STAFF RECOMMENDATION
2020 10th Avenue South
January 16, 2019

Application: Partial Demolition; New Construction—Addition;
District: Waverly-Belmont Neighborhood Conservation Zoning Overlay
Council District: 17
Map and Parcel Number: 10509041200
Applicant: Tarl LaRocco
Project Lead: Melissa Baldock, melissa.baldock@nashville.gov

Description of Project: Application is for a two-story addition behind the historic one-story house. The project involves removing part of an original wall on the left façade and substantially altering window openings.

Figure 4: Staff recommends that the only demolition allowed for the front portion of the building be the siding. Staff further recommends that the portion within the dashed-square retain the original window casings, but the window sashes, doors and porch posts may be replaced.

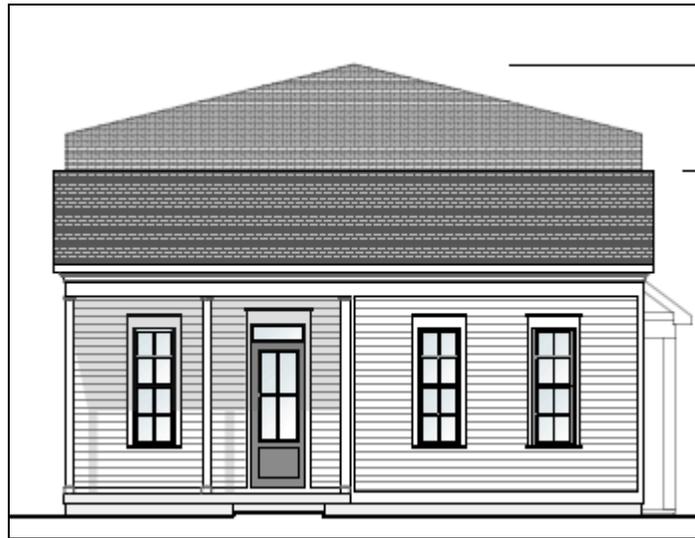
Partial Demolition: The applicant is proposing several changes to the historic house, which are considered to be partial demolition. In the staff recommendation for the proposed full demolition of the house, staff listed the areas for demolition that could be acceptable (Figure 4). For the front portion of the building, the only removal of material permitted would be the removal of the non-historic siding. For the middle and rear section, staff recommended that the window casings be retained, but that the window sashes, doors, and porch posts may be replaced. The applicant’s drawings show more extensive demolition of historic features than what staff finds to be appropriate.

Figure 9. The existing exterior wall that is to be removed.

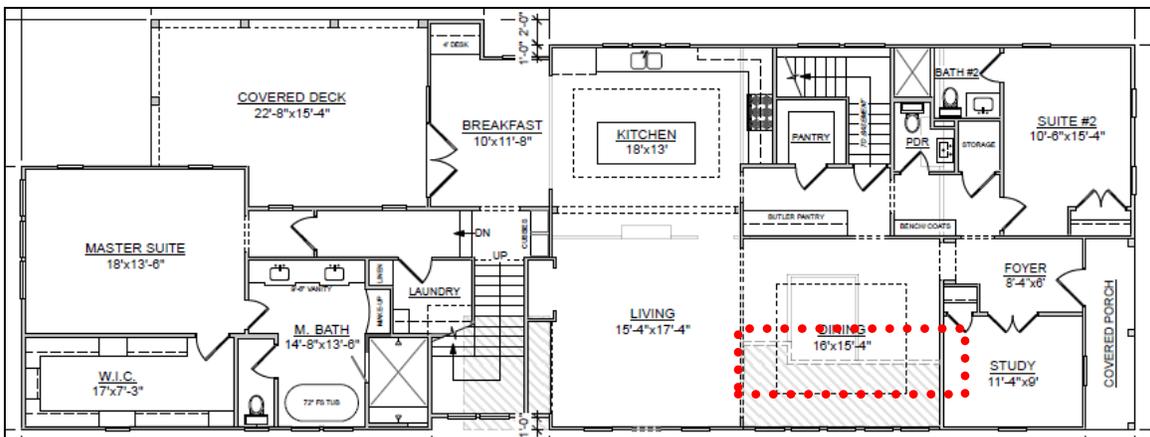
The applicant is also proposing to remove an existing, historic exterior wall behind the side porch (Figures 9 & 10). Staff finds although replacing the porch posts and screening the side porch may be appropriate, it is not appropriate to remove the existing exterior wall in order to create more interior space. The Sanborn maps from 1908, 1914, and 1957 all show that this area was always a side porch (Figures 11, 12, and 13). Staff finds the side porch configuration is a significant part of this historic house's form and should be preserved. It could be appropriate to screen or enclose the side porch in a manner that preserves the wall behind it and to keep the area open in nature.

Figure 16. Staff finds that the removal of the appendage at the rear of the house to be appropriate.

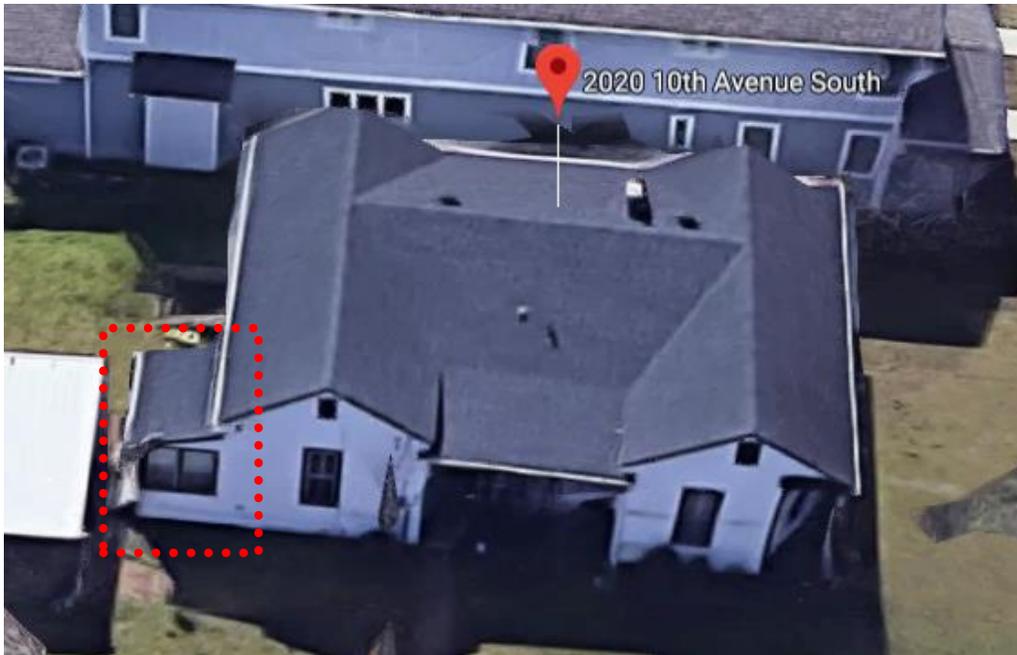
The applicant is proposing further to remove a small, rear porch portion of the house (Figure 16). The rear porch of the house is not seen in any of the older maps for the house and was therefore likely constructed after 1957. The structure has a separate roof form from the rest of the house, and staff finds that its date of construction, location at the rear of the house, and roof form do not contribute to the historic character of the house. Finally, the applicant is proposing to remove a detached rear carport and a detached garage (Figure 17). Neither structure appears on the 1957 Sanborn map, and neither contributes to the historic character of the house, the site, or the overall neighborhood. Staff therefore finds demolition of the rear porch, garage, and carport to be appropriate.

SITE PLAN
2020 10TH AVE S

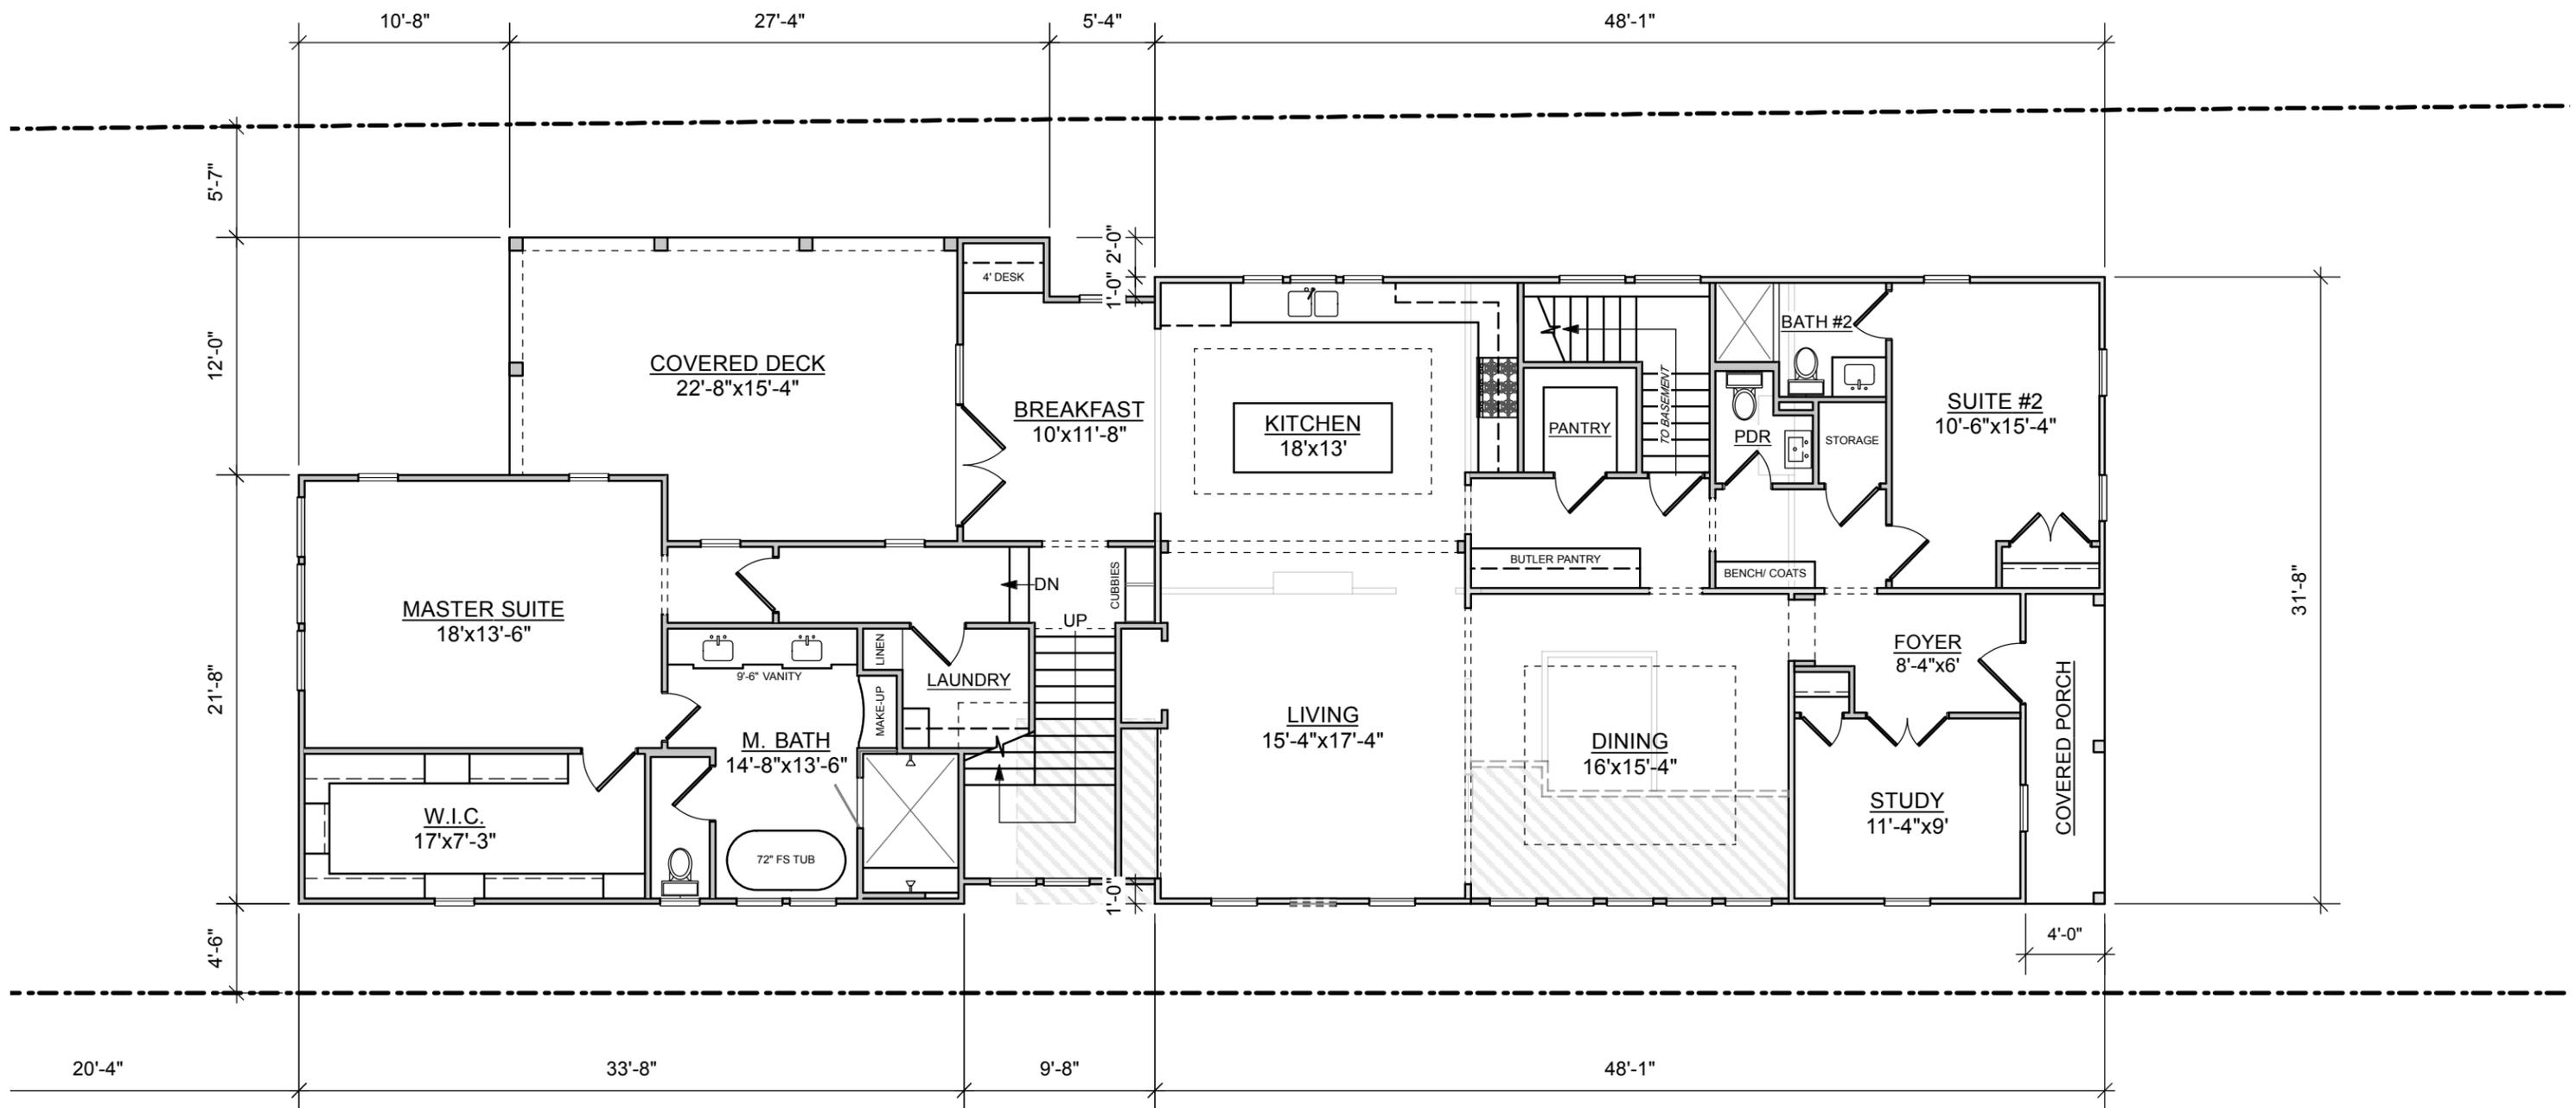
Setback & Rhythm of Spacing: The site plan shows that the addition meets all base zoning setbacks. It shows that the addition will be five feet (5') from the left side property line and five foot, three inches (5'3") from the right side property line. It will be over fifty feet (50') from the rear property line. Staff notes, however, that the first floor plan shows different setbacks. It shows the addition as being four foot, six inches (4'6") from the left side property line and five foot, seven inches (5'7") from the right side property line. Since the official survey for the lot shows the existing house as being five feet (5') from the side property line and both plans show the addition as lining up with the historic house, staff assumes that the site plan is correct and the first floor plan is erroneous. Although staff finds that the proposed setbacks as shown on the site plan are appropriate and meet Sections III.C. and IV. of the design guidelines, staff recommends that all future drawings show the accurate setbacks.

Outbuildings: Although the site plan shows a garage, no elevation drawings were submitted for the outbuilding. The outbuilding is therefore not part of this application.

2018 10th AVE S
2ND FLOOR

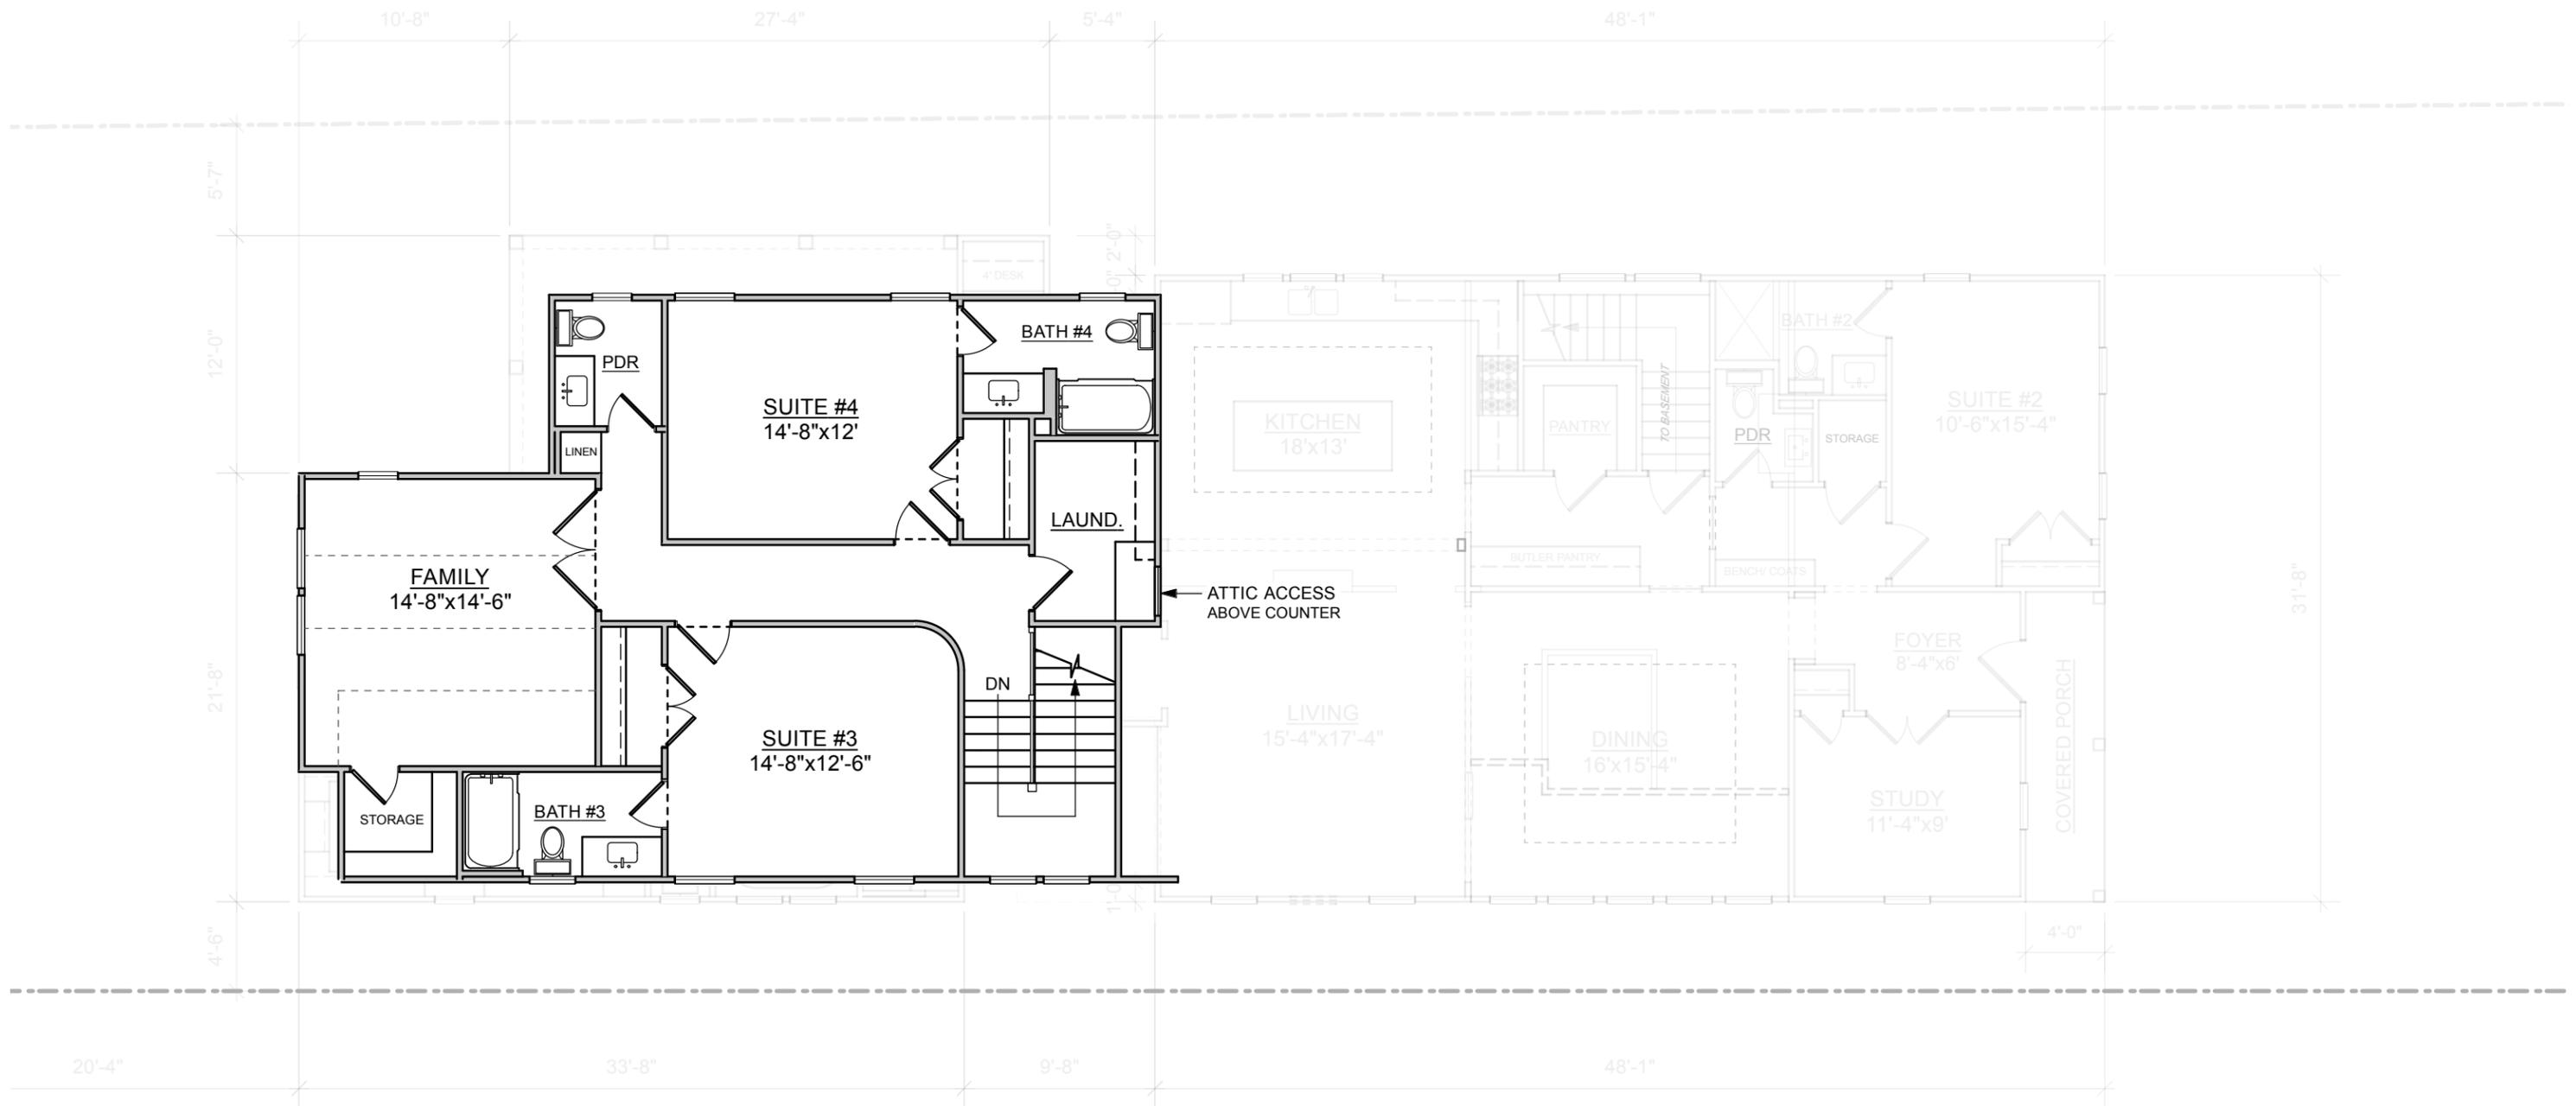
Height & Scale: The applicant is proposing a two-story addition to this one story house. The addition is proposed to be five feet, eleven inches (5'11") taller than the historic house. The design guidelines state, "*when a taller addition is the only option, additions to single story structures may rise as high as 4' above ridge of the existing building.*" In this case, staff does not see a taller addition as the "only option" for adding onto this house. There are no site constraints or easements to prevent the applicant from adding onto the rear with an addition that is no taller than the historic house. Staff finds a two-story or even a one-and-a-half story addition to be inappropriate to this true one-story. Because this house is possibly the oldest house in the Waverly-Belmont Neighborhood Conservation Zoning Overlay, staff finds that the only appropriately-scaled addition would be a one-story addition that extends no taller than the historic house.

Staff further notes that the addition is not inset appropriately for its scale. The addition is inset just one foot (1') from each of the back corners and then steps back out. The taller portion of the addition is not inset at all, and the Commission typically requires a two-foot inset for taller two-story additions. If the addition were reduced in height to be a true one-story addition that is no taller than the historic house, then a one foot (1') inset would be appropriate. However, the lack of an inset for the taller portion of the addition further underscores how out-of-scale it is for this historic house.

On the right side, after the inset of one foot by five feet (1'X5'), the addition steps back out and extends to be two feet (2') wider than the historic house. The design guidelines state that wider additions are appropriate when the historic house is less than thirty feet (30') wide and is shifted on the lot. However, this house is over thirty feet (30') wide and is centered on the lot. The Commission sometimes has approved wider additions when lots are wider than the typical lot in the neighborhood or area unusually shallow. It is the opposite for this lot. It is unusually narrow at just forty-five feet (45') wide, and is fairly deep at two hundred feet (200') deep.
